ADDENDUM NO. 1

Project Designation: 16070 - JJSD #251 Harwood Elementary Addition and Remodel

For: Jefferson Joint School District No. 251

Date: April 29, 2019

A1.4

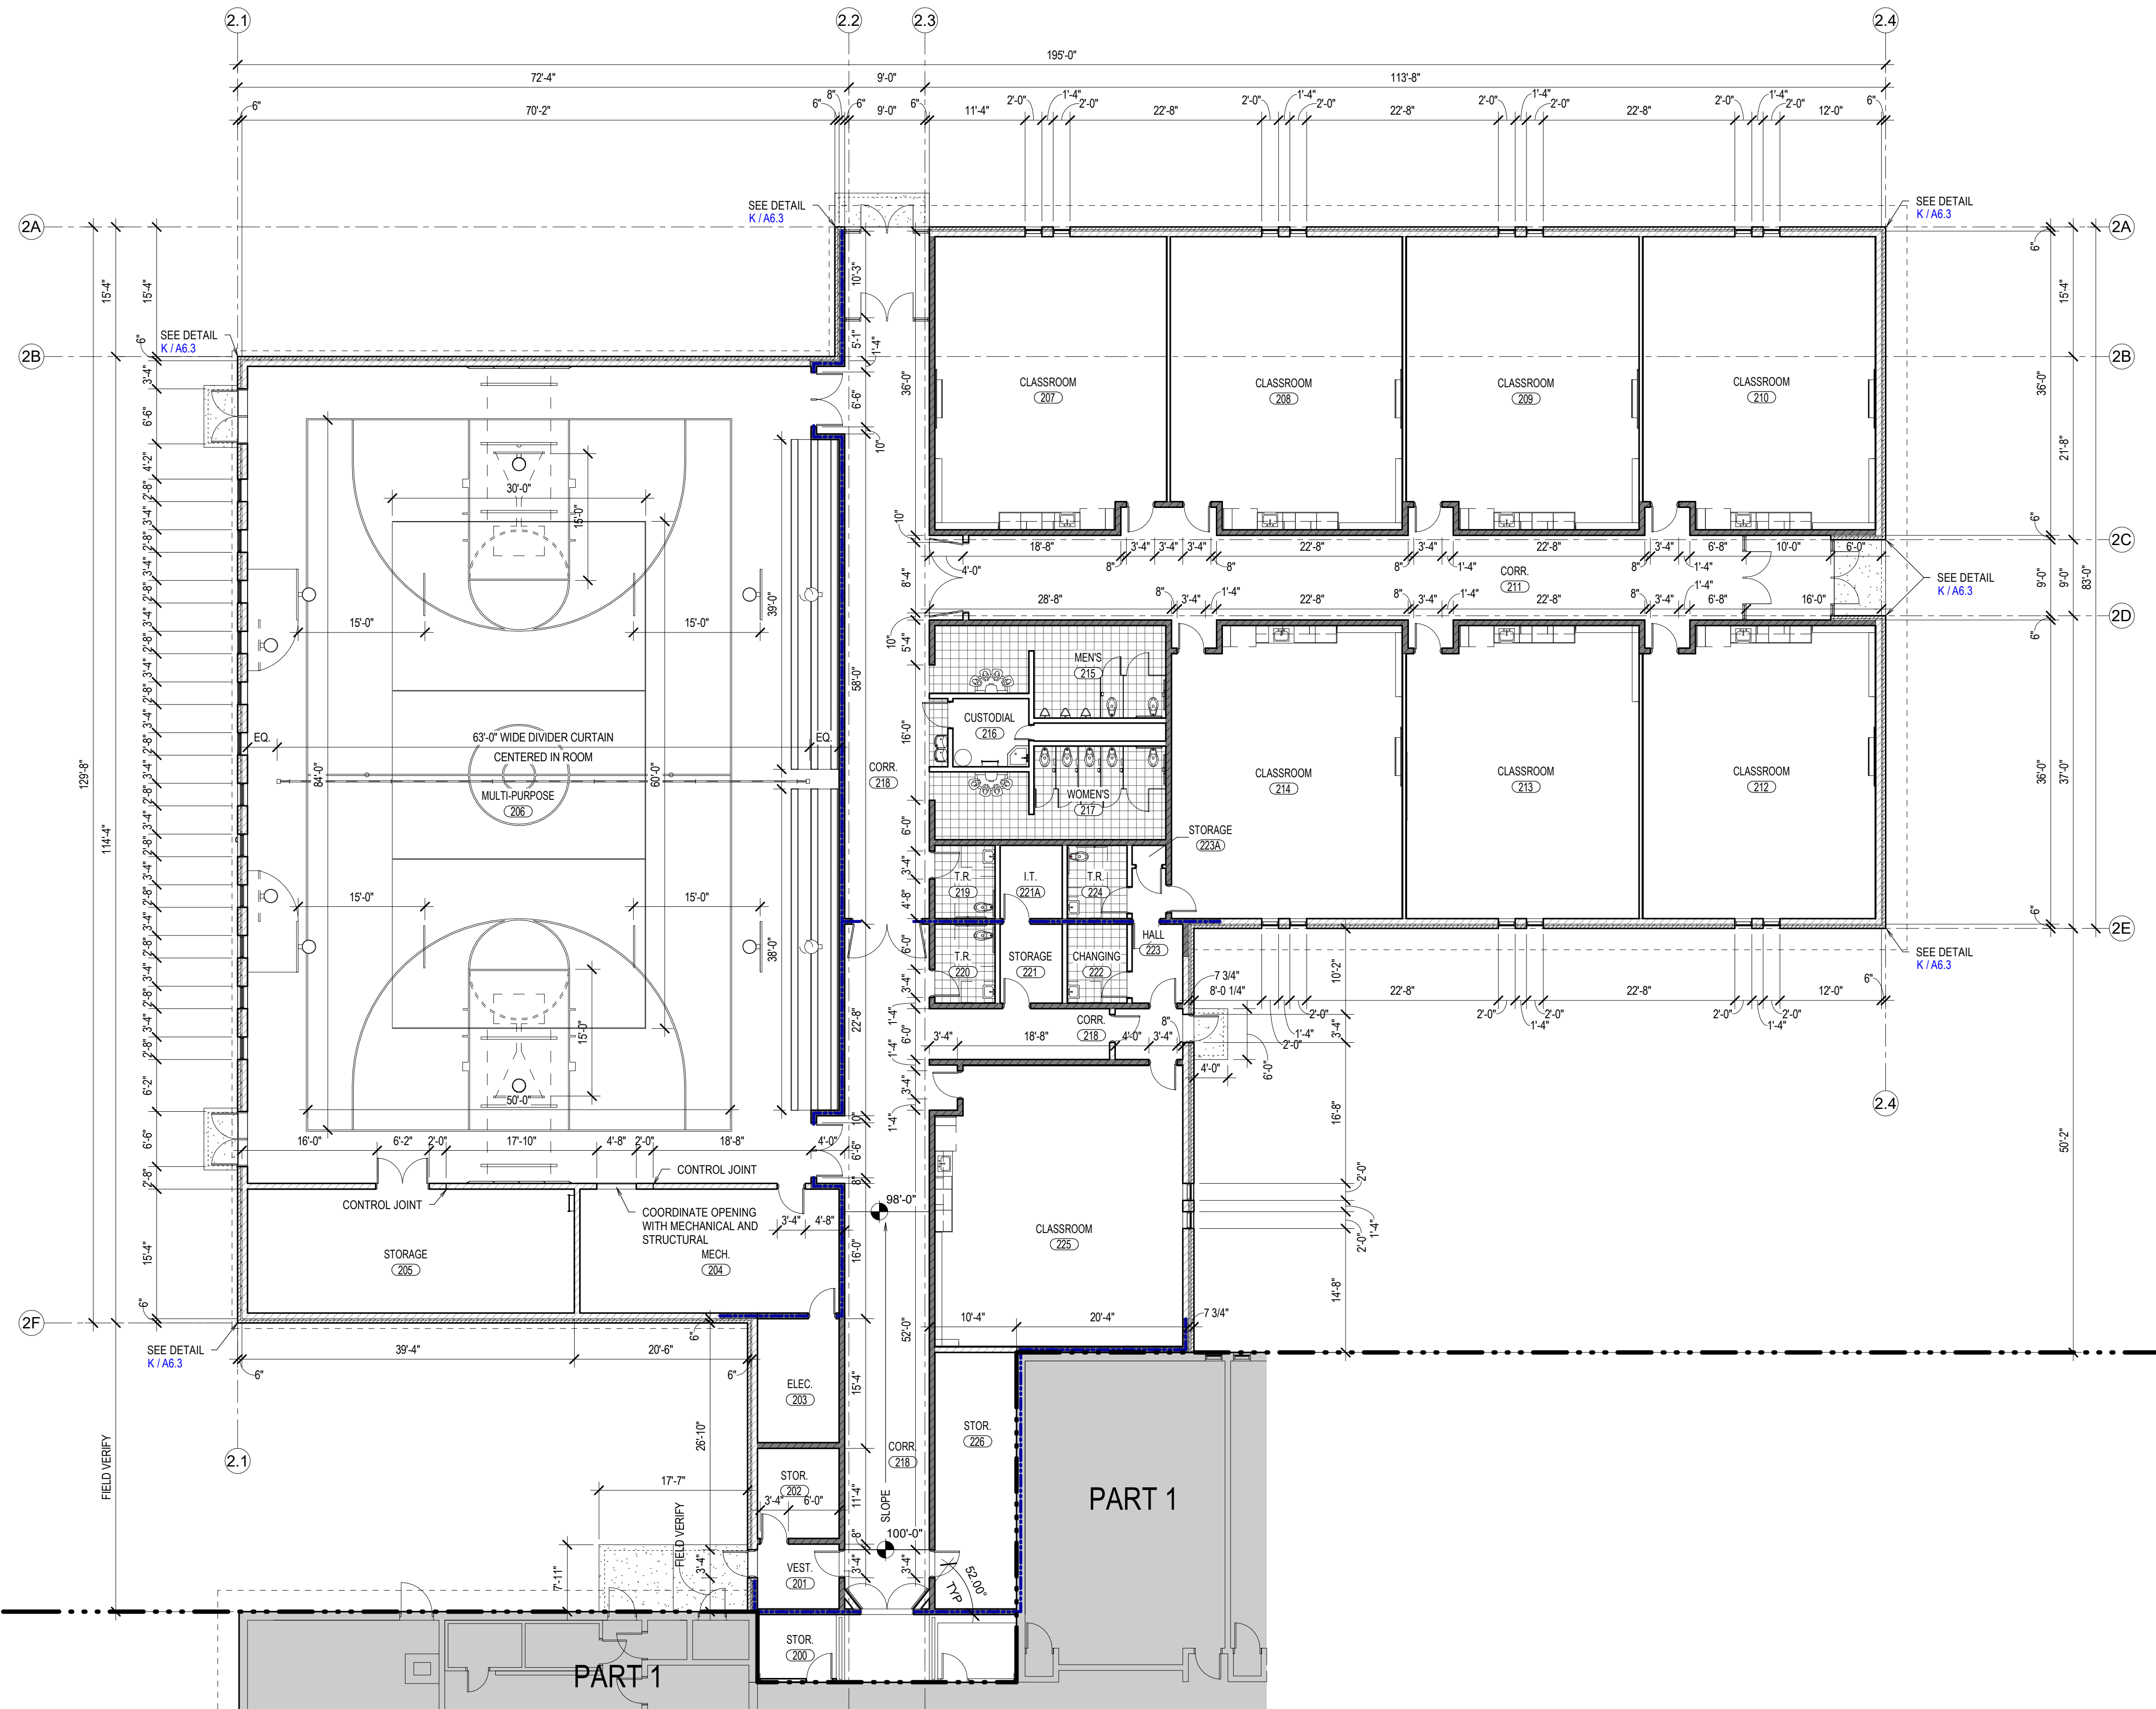
6. See revised sheet **A1.3** and **1.6**
 - a. General Note #8 added.
7. See revised sheet **A1.4**
 - a. New ceiling in existing large restrooms. Additional General Note #4 added.

- b. New Acoustical Ceiling and Type in Kitchen 118.
8. See revised sheet **A1.7**
 - a. Additional General Note #4 added.
 - b. New ceiling section callouts. New section detail.

A7.1

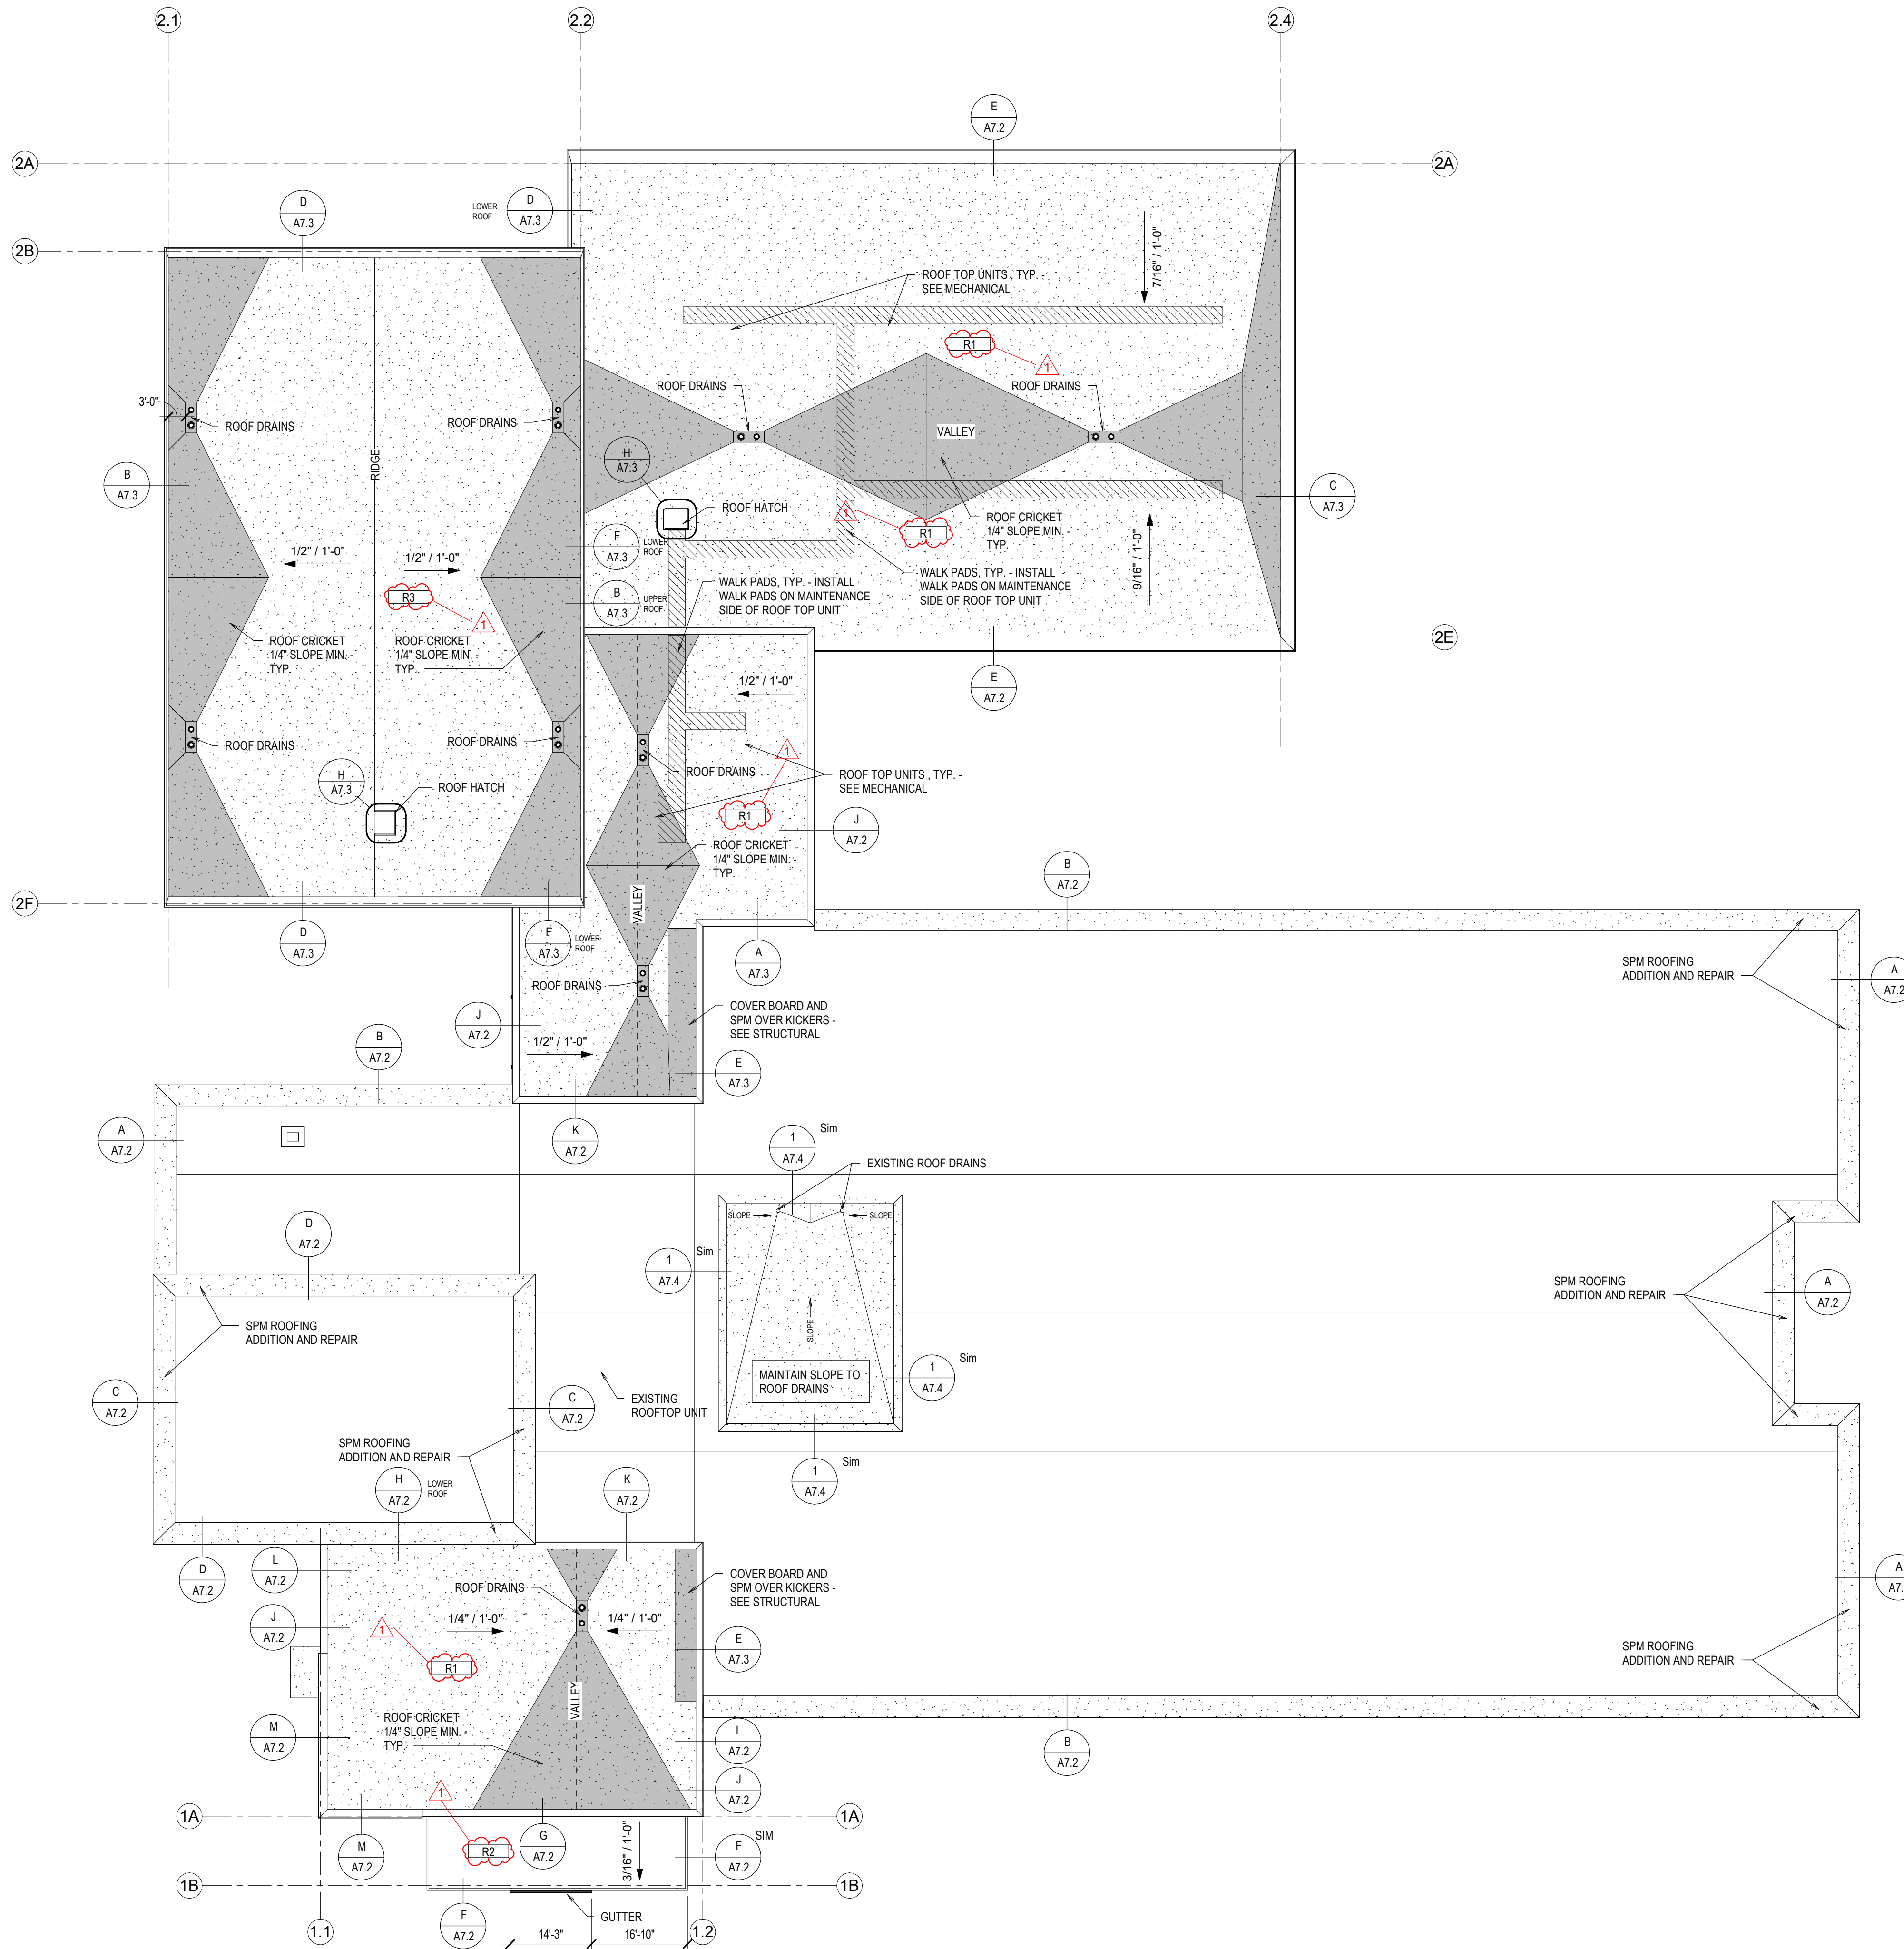
9. See revised sheet **A4.1 – 4.5**
 - a. Changed Keynote referencing the slab vapor barrier.
 - b. Keynote #719 changed.
10. See revised sheet **A7.1**
 - a. Roof Types called out.
